RE: Meadow Lane Retaining Wall Replacement

**Subject: Fieldstone Farms (aka Meadow Lane)
Retaining Wall Replacement Plan Review**

- Plans entitled Retaining Wall Replacement Located at Meadow Lane, Grafton, MA dated April 10, 2017 and last revised July 24, 2017, prepared by Land Planning, Inc. for Magill Associates, Inc. (2 sheets)

North Retaining Wall Elevation

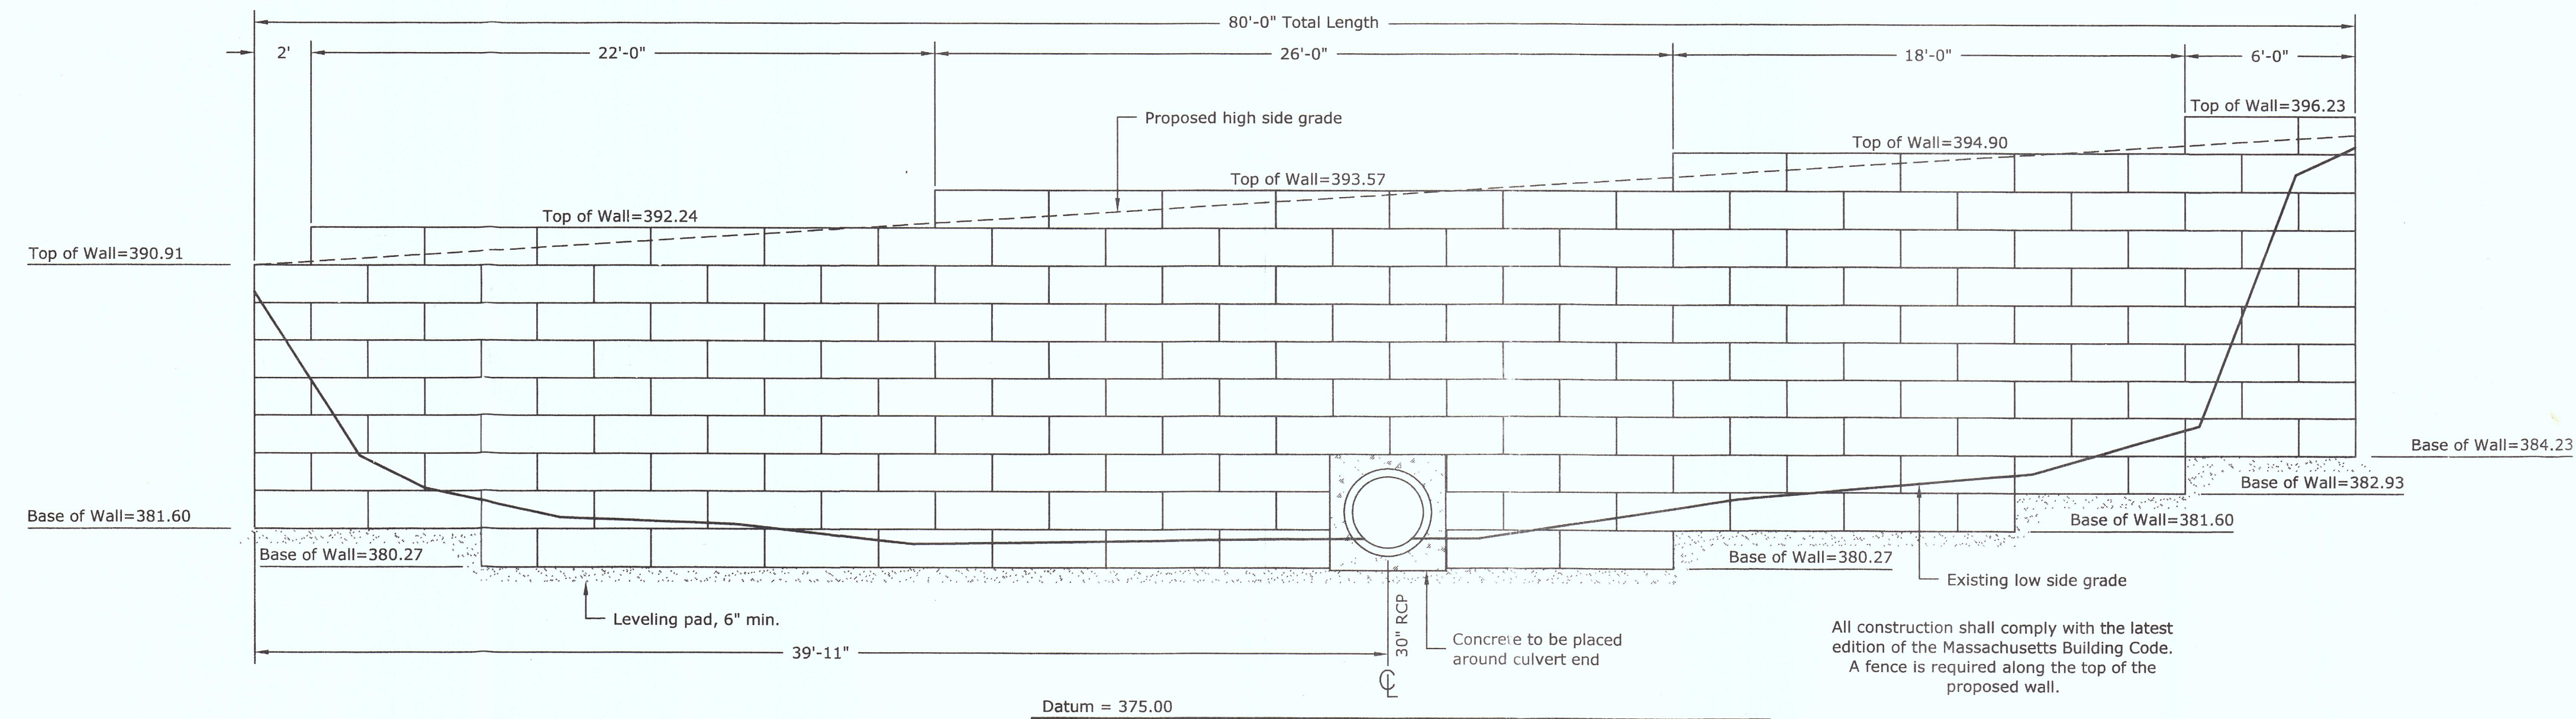
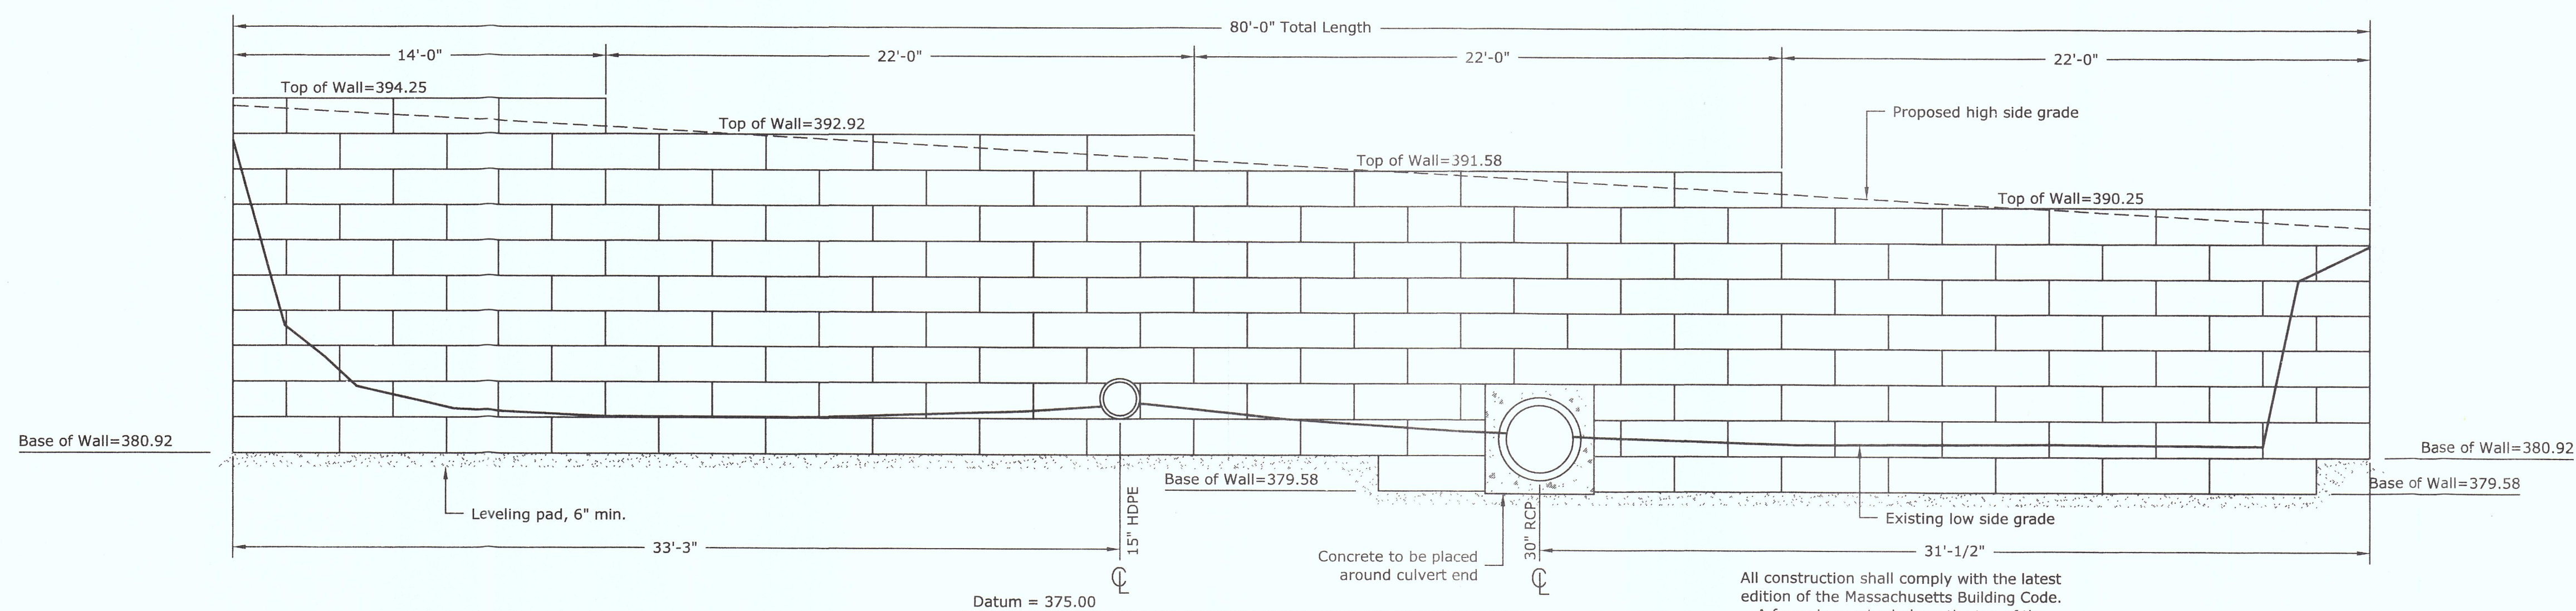
4. *On Sheet 1, the individual blocks weren't labeled on the two retaining wall elevations. Standard practice for wall systems such as the one proposed is to label the block type (e.g. 60B, 60M, 45M, 24T) of each block to avoid confusion during construction. For example, there are sections of the walls that require nine courses adjacent to sections that require ten courses, each of which requires different base blocks.*

The blocks were labeled as requested. On the right side of the "North Retaining Wall Elevation" there are two base blocks labeled as 60M that need to be revised to 60B.

4. *On Sheet 1, the individual blocks weren't labeled on the two retaining wall elevations. Standard practice for wall systems such as the one proposed is to label the block type (e.g. 60B, 60M, 45M, 24T) of each block to avoid confusion during construction. For example, there are sections of the walls that require nine courses adjacent to sections that require ten courses, each of which requires different base blocks.*

The blocks were labeled as requested. On the right side of the "North Retaining Wall Elevation" there are two base blocks labeled as 60M that need to be revised to 60B.

5. *On Sheet 1, the individual blocks weren't labeled on the two retaining wall elevations. Standard practice for wall systems such as the one proposed is to label the block type (e.g. 60B, 60M, 45M, 24T) of each block to avoid confusion during construction. For example, there are sections of the walls that require nine courses adjacent to sections that require ten courses, each of which requires different base blocks.*
The blocks were labeled as requested. On the right side of the "North Retaining Wall Elevation" there are two base blocks labeled as 60M that need to be revised to 60B.

5. On Sheet 1, the individual blocks weren't labeled on the two retaining wall elevations. Standard practice for wall systems such as the one proposed is to label the block type (e.g. 60B, 60M, 45M, 24T) of each block to avoid confusion during construction. For example, there are sections of the walls that require nine courses adjacent to sections that require ten courses, each of which requires different base blocks.

Acknowledged. The remaining two labels on Sheet 1 were revised.

Acknowledged. The remaining two labels on Sheet 1 were revised.

7 Course Wall Section

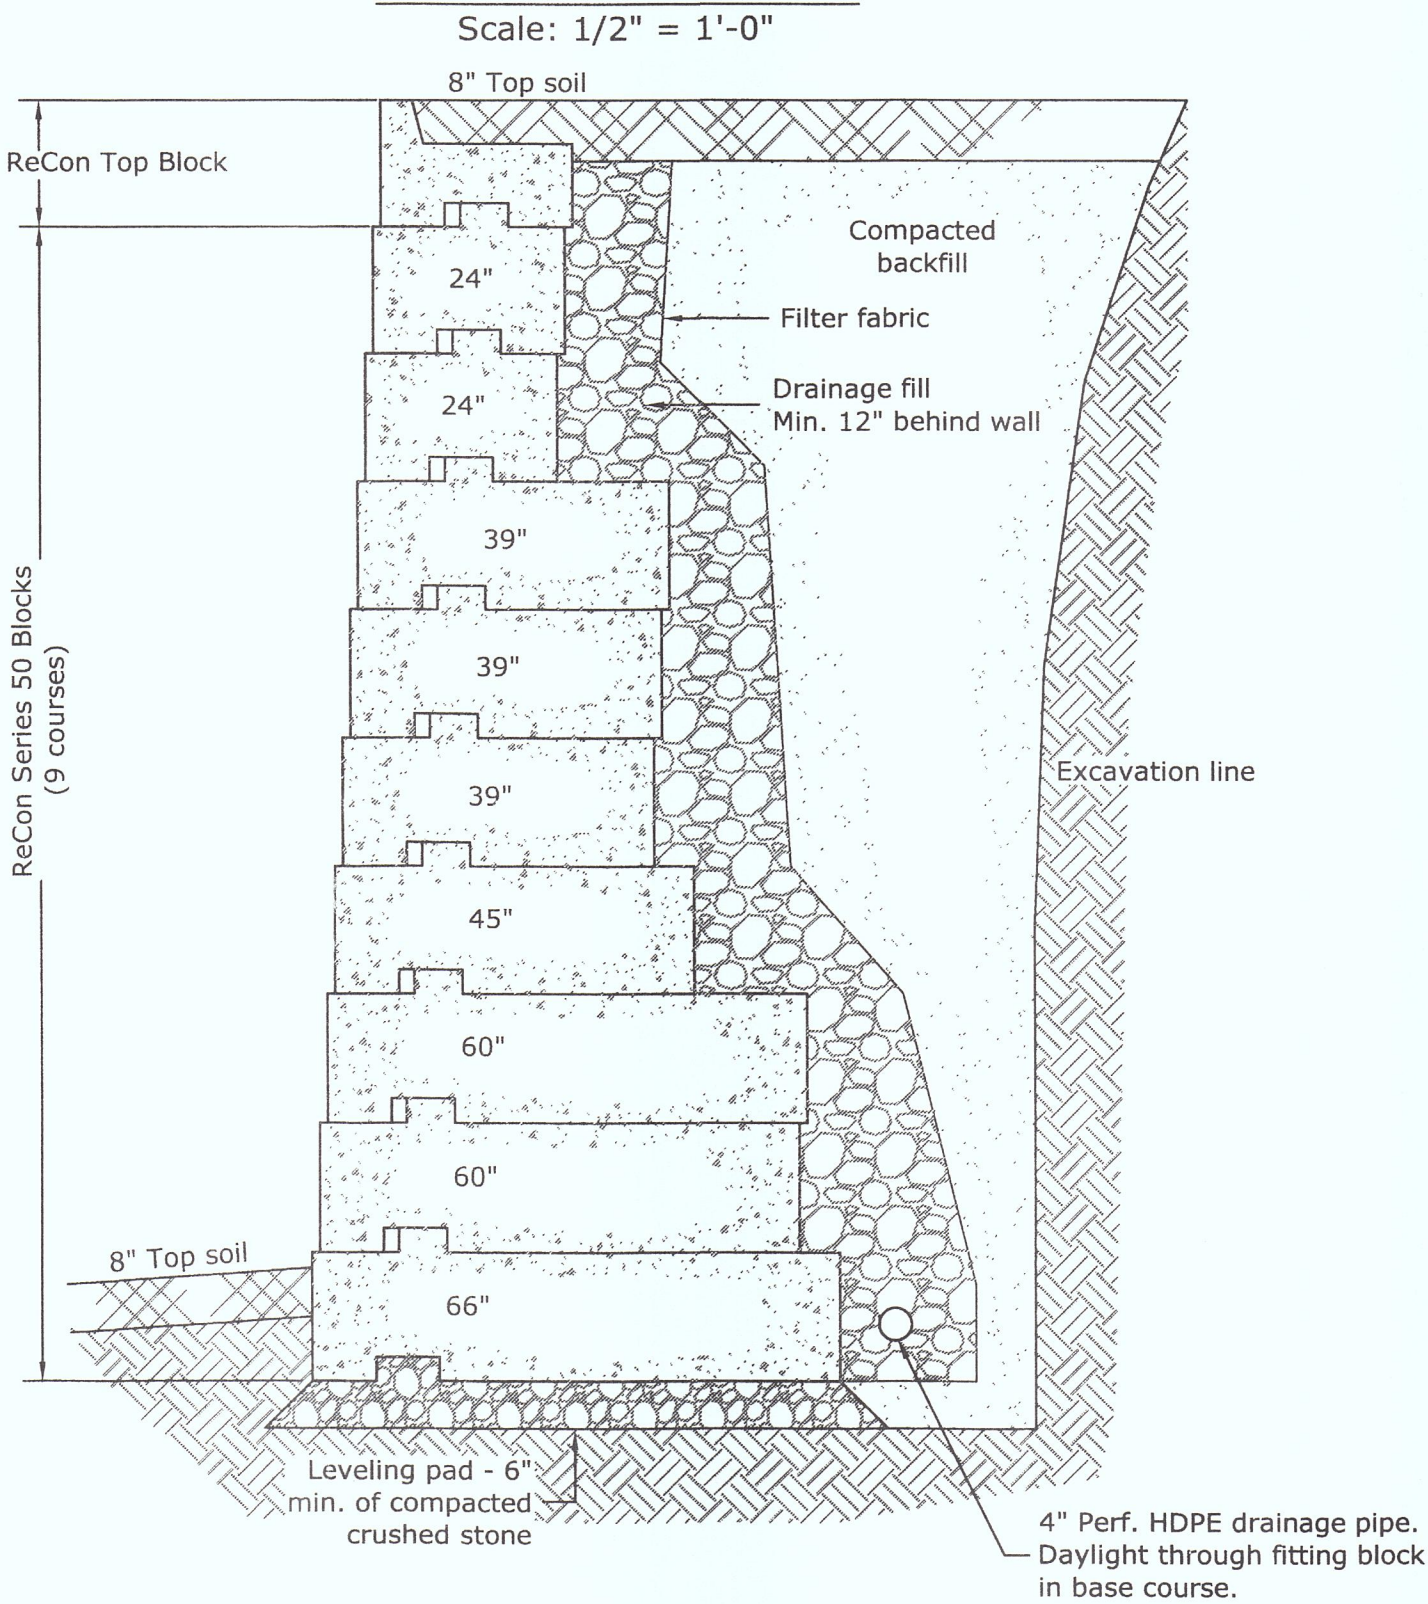
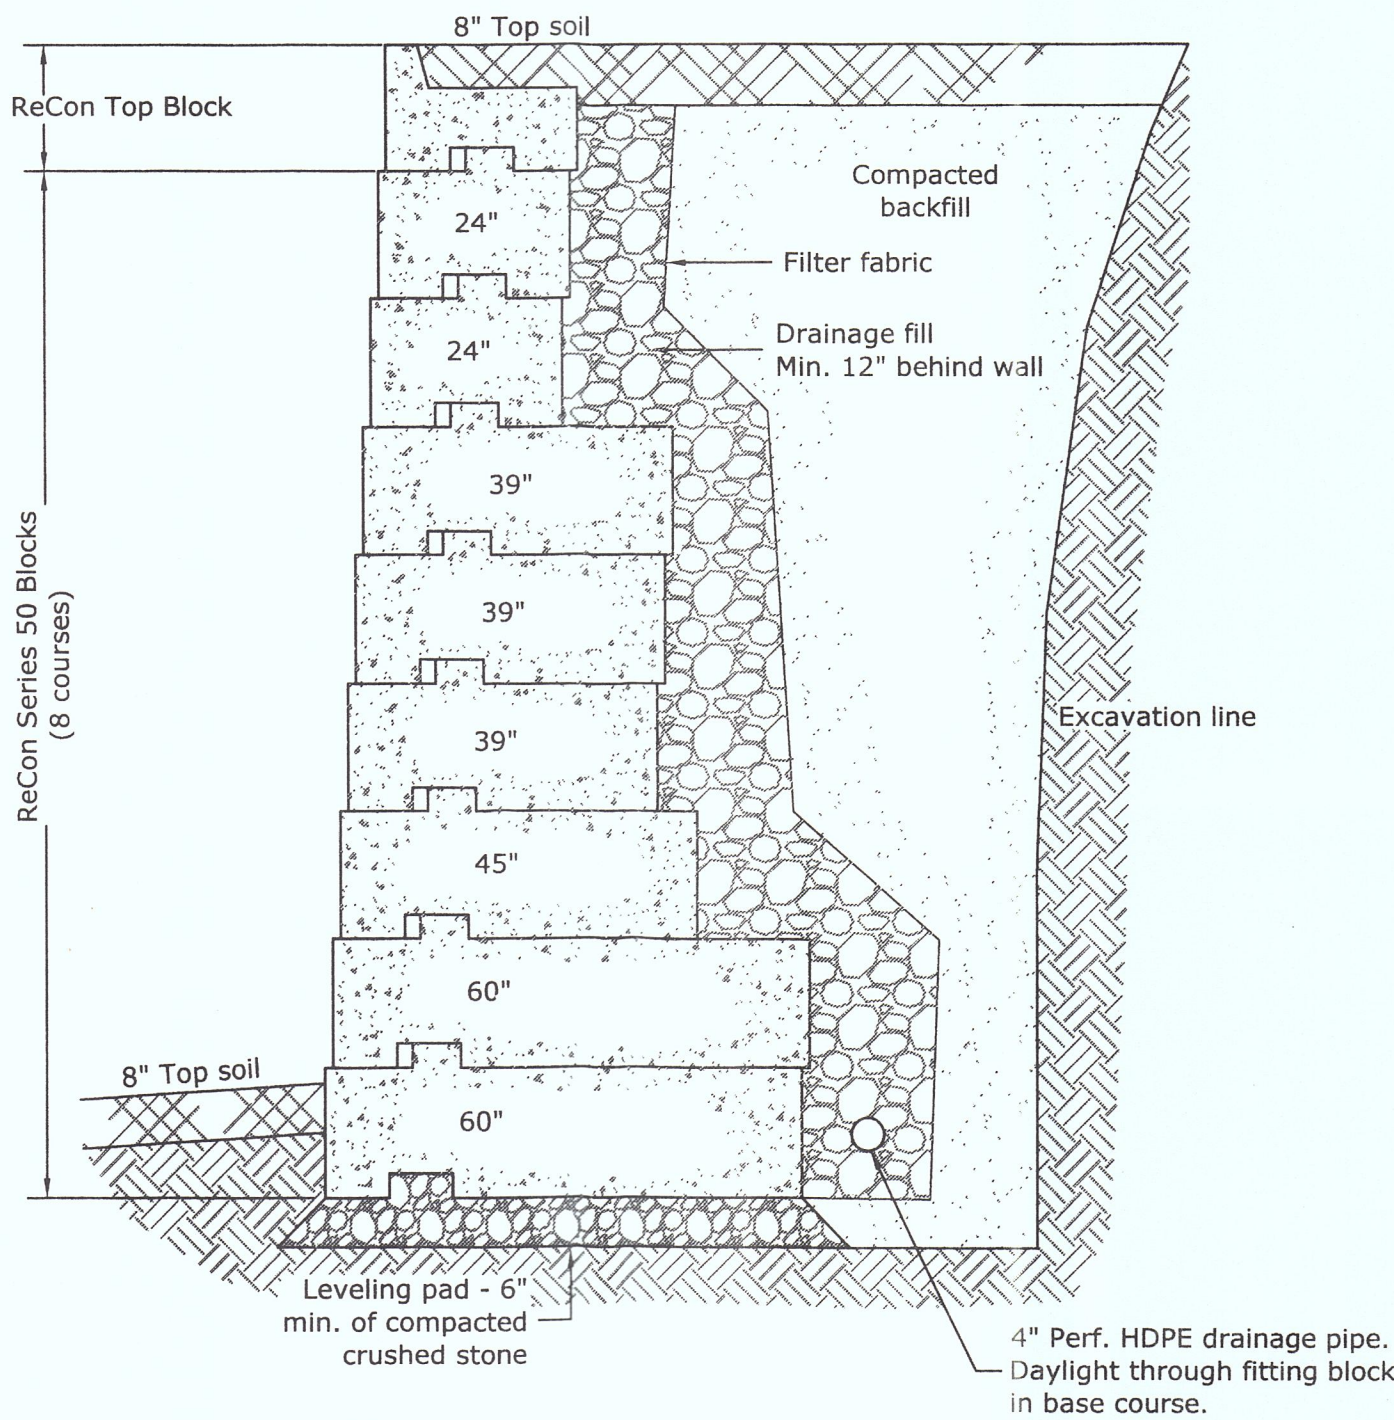
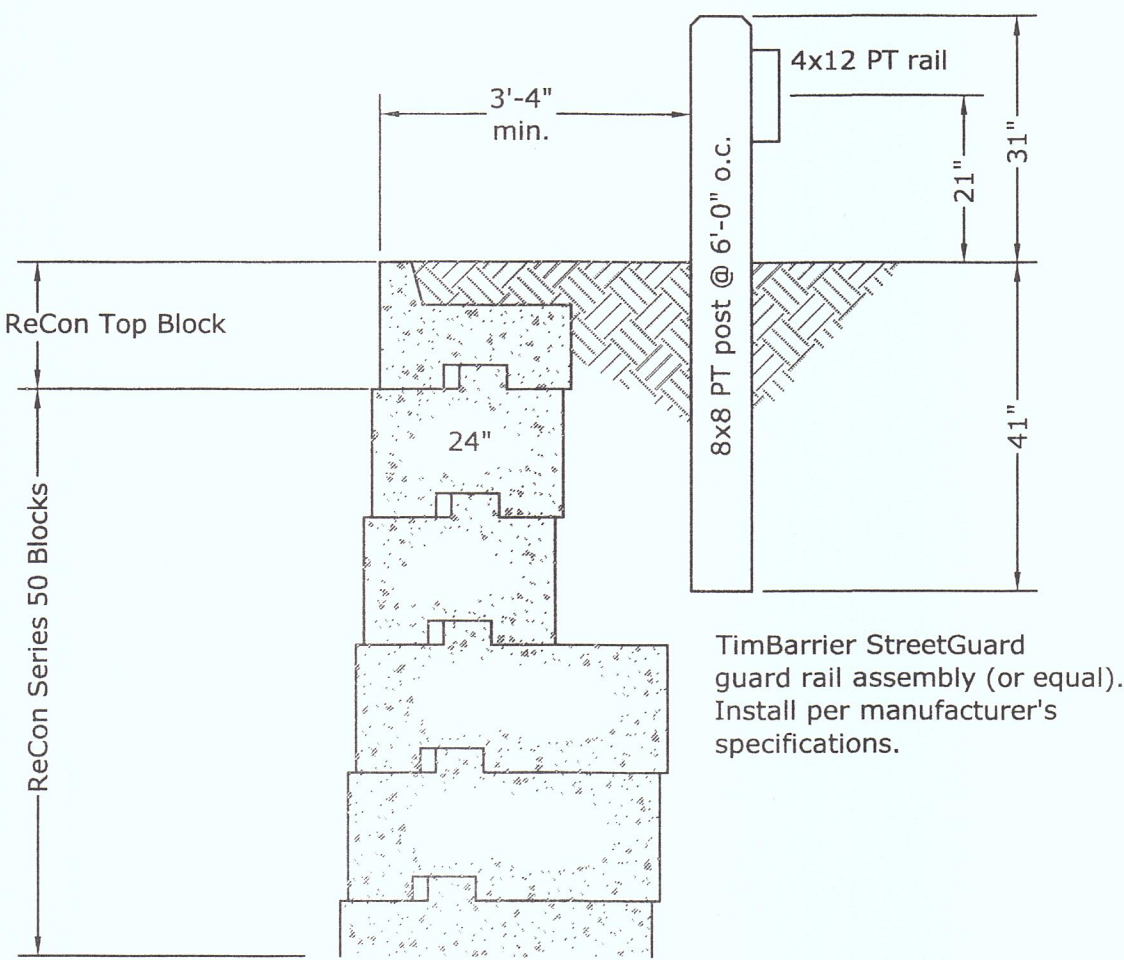
4. *The wall section construction details on Sheet 2 show the base blocks having grooves in their bottom (these are middle blocks) instead of having a flat bottom (base blocks). The construction details must be revised to show base blocks.*
Acknowledged. The construction details were revised to show base blocks at the bottom of the walls.

4. The wall section construction details on Sheet 2 show the base blocks having grooves in their bottom (these are middle blocks) instead of having a flat bottom (base blocks). The construction details must be revised to show base blocks.

Guard Rail Placement Detail

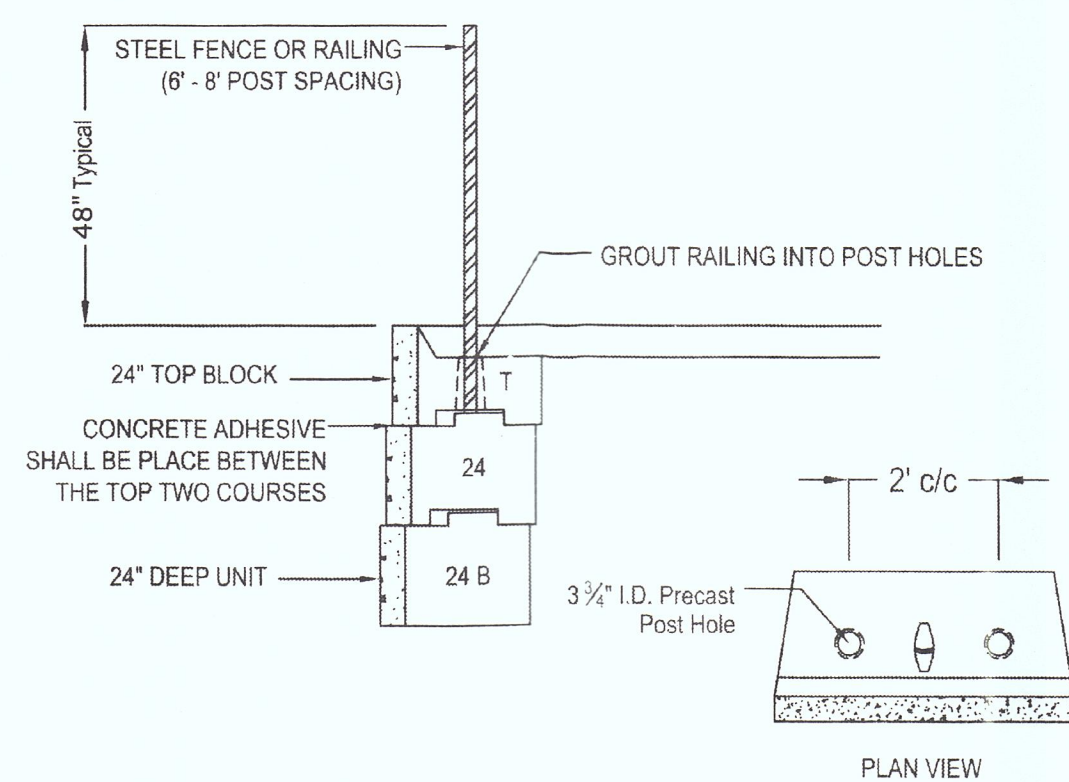
2. *Information available from the wall block manufacturer indicates that guard rail posts are to be set in a grout-filled Sonotube with a minimum embedment of five feet. The plans propose direct-burial posts embedded only 41" into the ground. The plans need to be revised to meet or exceed the manufacturer's recommendations.*

The plans were revised to include a Sonotube whose bottom is five feet below grade with a post length of only 41". The Sonotube offers little, if any, structural strength. Whereas the post is located near the retaining wall and protecting the wall's integrity is important, we understand that the post needs to be embedded five feet (per the wall manufacturer) even if this length exceeds the guard rail manufacturer's recommendation. The detail needs to be revised to provide a post embedment depth of at least five feet and to specify grout between the post and the Sonotube.

2. *Information available from the wall block manufacturer indicates that guard rail posts are to be set in a grout-filled Sonotube with a minimum embedment of five feet. The plans propose direct-burial posts embedded only 41" into the ground. The plans need to be revised to meet or exceed the manufacturer's recommendations.*

The plans were revised to include a Sonotube whose bottom is five feet below grade with a post length of only 41". The Sonotube offers little, if any, structural strength. Whereas the post is located near the retaining wall and protecting the wall's integrity is important, we understand that the post needs to be embedded five feet (per the wall manufacturer) even if this length exceeds the guard rail manufacturer's recommendation. The detail needs to be revised to provide a post embedment depth of at least five feet and to specify grout between the post and the Sonotube.

3. *Information available from the wall block manufacturer indicates that guard rail posts are to be set in a grout-filled Sonotube with a minimum embedment of five feet. The plans propose direct-burial posts embedded only 41" into the ground. The plans need to be revised to meet or exceed the manufacturer's recommendations.*
The plans were revised to include a Sonotube whose bottom is five feet below grade with a post length of only 41". The Sonotube offers little, if any, structural strength. Whereas the post is located near the retaining wall and protecting the wall's integrity is important, we understand that the post needs to be embedded five feet (per the wall manufacturer) even if this length exceeds the guard rail manufacturer's recommendation. The detail needs to be revised to provide a post embedment depth of at least five feet and to specify grout between the post and the Sonotube.

3. Information available from the wall block manufacturer indicates that guard rail posts are to be set in a grout-filled Sonotube with a minimum embedment of five feet. The plans propose direct-burial posts embedded only 41" into the ground. The plans need to be revised to meet or exceed the manufacturer's recommendations.

Acknowledged. The "Guard Rail Placement Detail" was revised to show the post embedded five feet.

Acknowledged. The "Guard Rail Placement Detail" was revised to show the post embedded five feet.
